PROPOSED REVISIONS TO THE WHITEHOUSE TOWN CENTRE AND WHITEHOUSE SOUTH (AREA 10) DESIGN CODES

The Developer has submitted revisions to the Design Code submission for Whitehouse Town Centre and Whitehouse South (Area 10), under planning obligation requirements, together with a summary of comments so far.

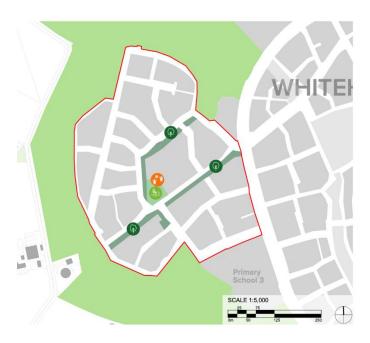
There is no mention of play area provision in the Whitehouse South design code. Given the size of the parcel, and its distance from existing play areas, there is an expectation to see one/more play areas included. Would planned play provision be included on the design guide or would this happen at a later stage in the planning process?

There's no key to the map (disappointingly), but the orange icon may be meant to signify a play area:

But on the detailed plan for Whitehouse South Green there's no mention of play equipment:

MKCC are discussing this query with the applicant, but no response has yet been received.
